Proposal how to structure the RESS safety requirements

12-14 April 2011

Color-code:

- Red = RESS-3-7 Vibration_Draft_JP_Proposal
 + Further comment (in dotted box) / proposal (with yellow marker)
- Green = Remarks or amendments by the secretary
- Purple = Remarks from TÜV and BMW under § 3.7
- Blue = Remarks from France

Diagram 1 – minimum shock pulse

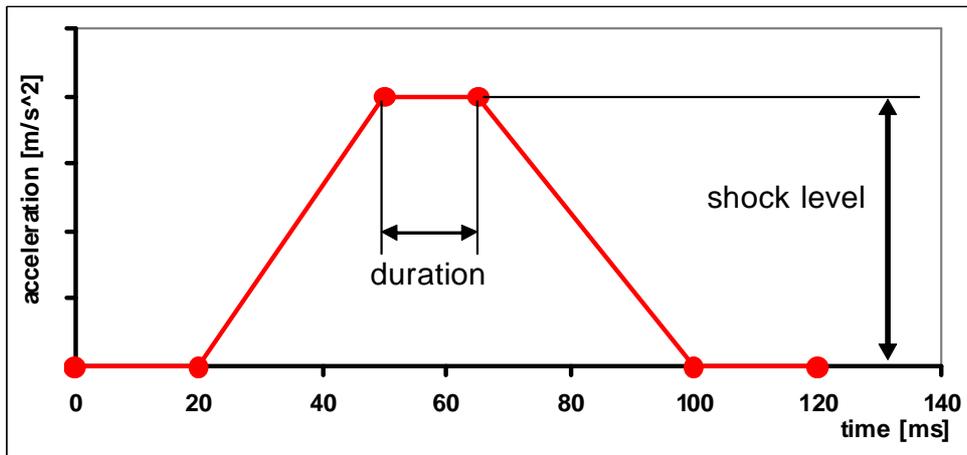
Remark:

Frontal impact: the R 17 corridor should be incorporated in the diagram 1 (upper limit). As it is said in the test protocol § 3.4 in RESS 3-3, the test undergoes by the device can be performed via the R94 on the vehicle. So at least, the device pulse has to be equivalent to the vehicle pulse.

The R17 corridor is a frontal impact R12 simulation in order to validate seat entities. The same philosophy is applied for example to the CRS in R44 with a stronger requirement (fixed rise time).

So, we think the half sinus proposed does not totally cover the need and we think the R17 corridor is more representative and relevant solution for this RESS test. Therefore, a half sinus included in the R17 corridor would be also acceptable.

Lateral impact: We propose to use the same pulse taken from R 17 with a lower test levels and a lower duration. At this time, we need more time to define exactly the signals characteristics.

Diagram 2 – sinus shock pulse

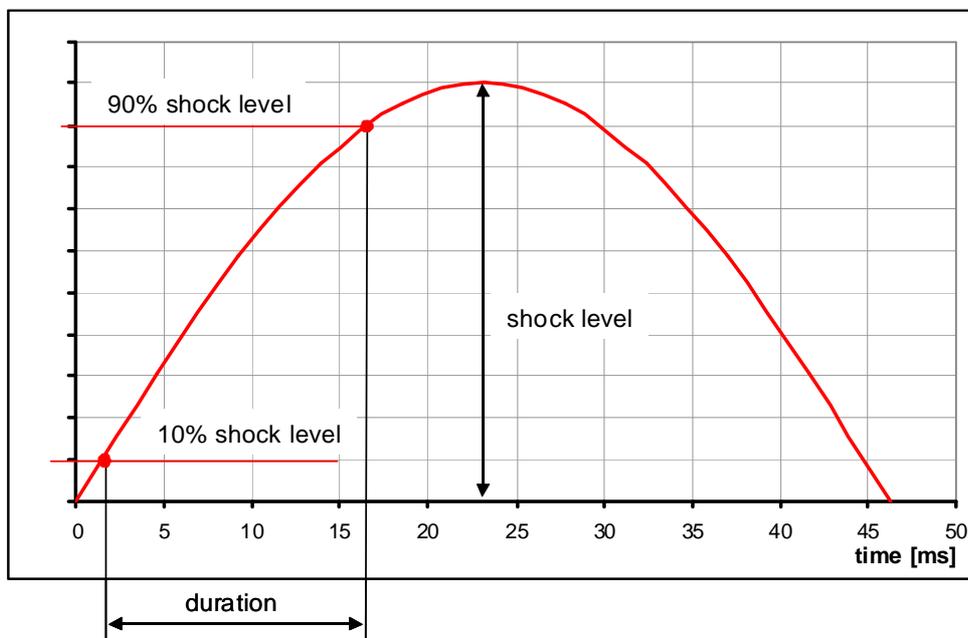
<JASIC Comment>

Pulse a) and b) are not considered as equivalent and pulse b) will be difficult to achieve at lower shock level.

Figure 7:

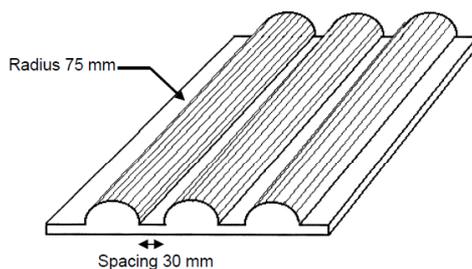
Crush a [RESS or pack(s)] between a resistance and a crush plate described in figure 7 with a force of [100 kN] in [X seconds; how fast] during [Y seconds; how long] => **action item for German working group**

~~To better precise the crush plate position with a drawing.~~
